**Re: PEPACR-2020-01, In the Matter of the Annual Consolidated Report of Potomac Electric Power Company**

**INITIAL COMMENTS OF THE OFFICE OF THE PEOPLE’S COUNSEL  
FOR THE DISTRICT OF COLUMBIA REGARDING PEPCO’S  
2020 ANNUAL CONSOLIDATED REPORT**

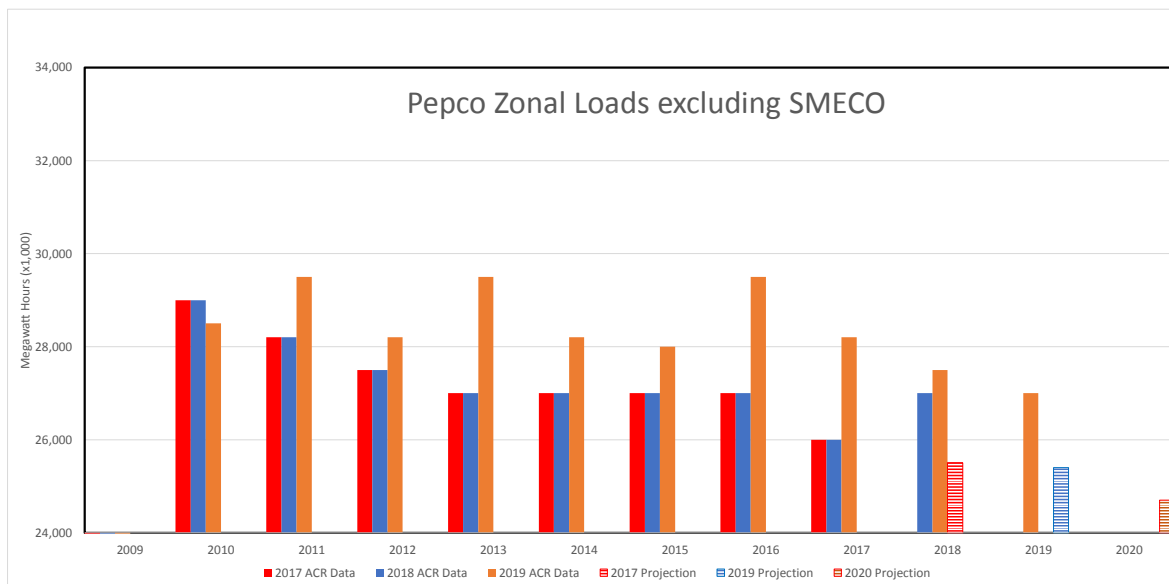
The system power factor is one measure of how efficiently Pepco’s electric system is being operated. The power factor is the ratio between kilowatts (kW) and apparent power (kVA). The driving force for power factor is the reactive power (kvar) which is created by the customers’ end-use electrical devices and can also be influenced by the reactive nature of underground medium voltage power cables. A unity power factor would be ideal but not practical. Pepco plans for a 0.98 (98%) power factor.<sup>19</sup> There has been a steady decline in the number of substations with power factors greater than 0.98. The number of substations with a power factor less than 0.98 increased from 3 substations to 4 substations from 2013 to 2017 and further increased to 9 substations in 2018. Currently, 13 substations in 2019 exhibited power factors less than 0.98. This decline in power-factor efficiency is very disturbing considering the investments in automation

and remote control of capacitors on the distribution systems. OPC recommends Pepco report at PIWG meetings its efforts to maintain an efficient power factor for the system.

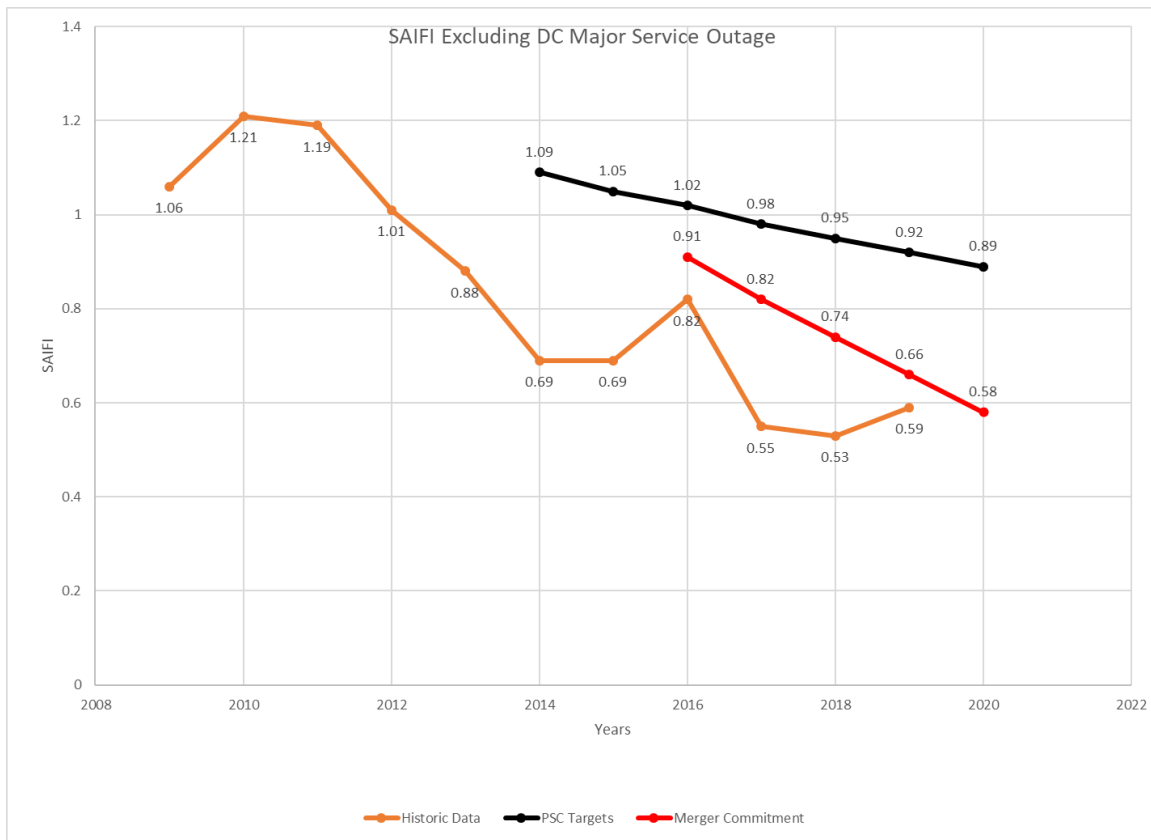
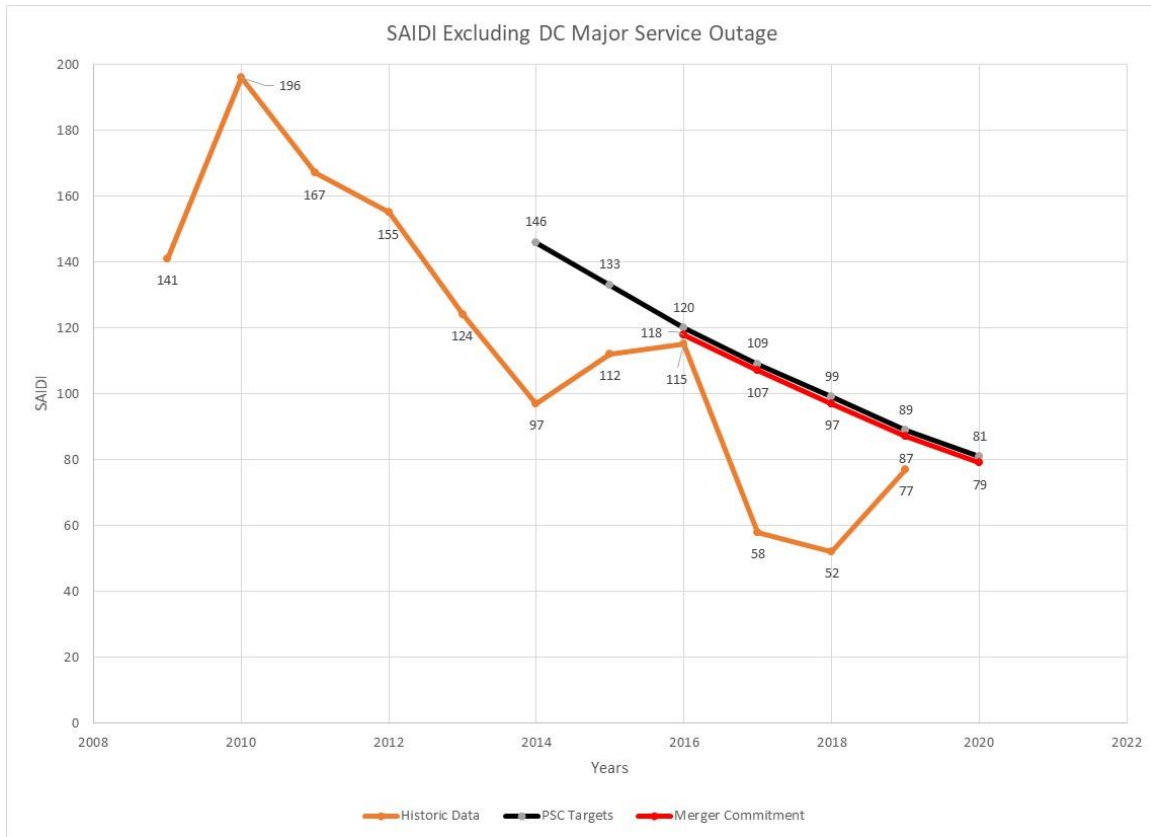
Pepco reported the SAIFI for 2019 as 0.59 and the SAIDI for 2019 as 1.29 hours (77 minutes),<sup>64</sup> which meet the EQSS and Merger Commitment. However, as shown in the following graphs, the SAIFI and SAIDI values have deviated from an otherwise admirable trend. OPC analyzed the sustained outage data for 2019 and identified that a major contributor to SAIFI and SAIDI is the extended outage at the Florida Substation in July. Had this outage not occurred, OPC’s estimate of SAIFI is 0.52 and SAIDI is 62 minutes. These adjusted values without the Florida Substation outage show Pepco had reliability on par with 2018 and 2017. This does not excuse the outage at Florida Substation, and OPC understands, based on a root cause analysis, Pepco is taking steps to correct problems with similar LTCs on the system.<sup>65</sup> However, OPC’s

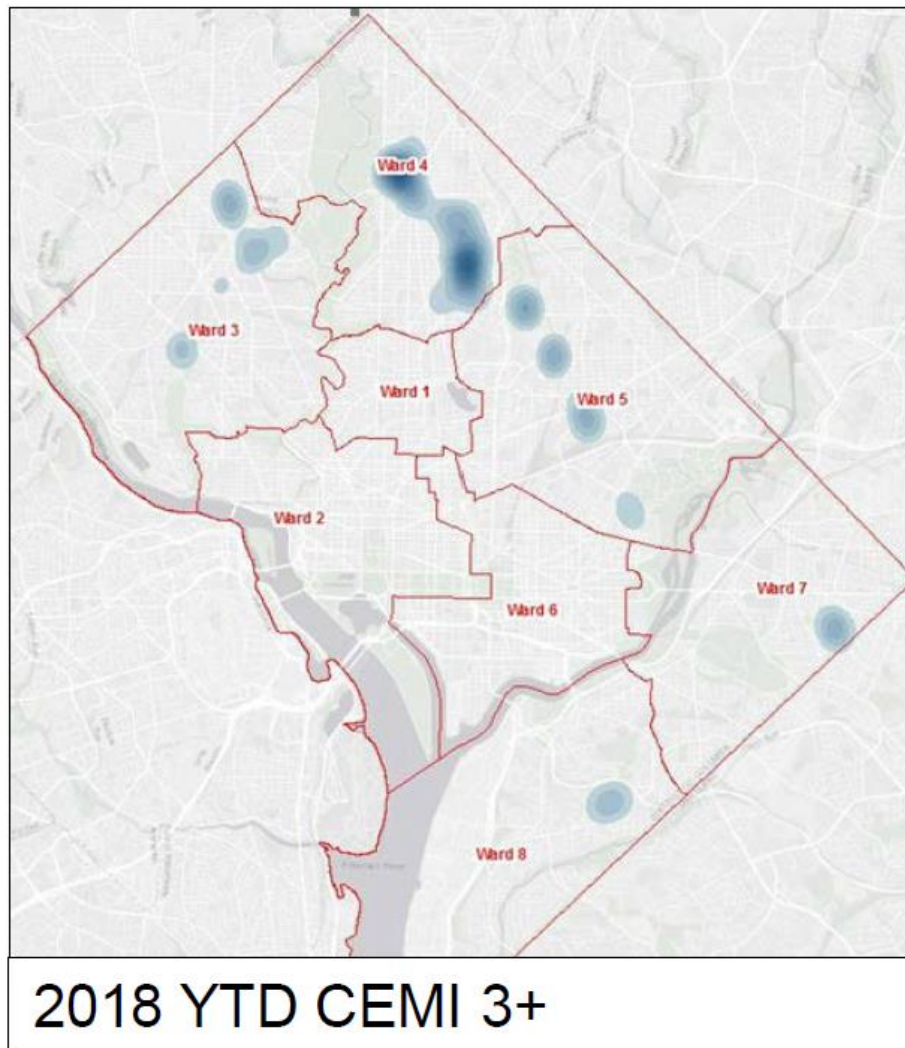
OPC has an interest in ensuring the reliability of neighborhoods across the District. Ratepayers do not see their community divided into service areas of feeders; all they see are neighborhoods. Pepco has changed its approach to neighborhood reliability now using a more defined geospatial approach to determine the most susceptible neighborhoods. This method is based on 250 customers experiencing multiple interruptions (“CEMI”) of 3 or more in a single year within that individual neighborhood.<sup>66</sup> It should be pointed out that an interruption is defined as any sustained electrical interruption of five minutes or more. Therefore, blinking lights are not included in this analysis. Pepco has provided a heat map at the PIWG meetings that graphically

depicts the location of the most susceptible neighborhoods.<sup>67</sup> The 2018 heat map for CEMI-3, which can aid stakeholders in understanding problem areas and how those problems get solved from one year to the next, is shown below.<sup>68</sup> OPC recommends that this graphic be included in future ACRs.
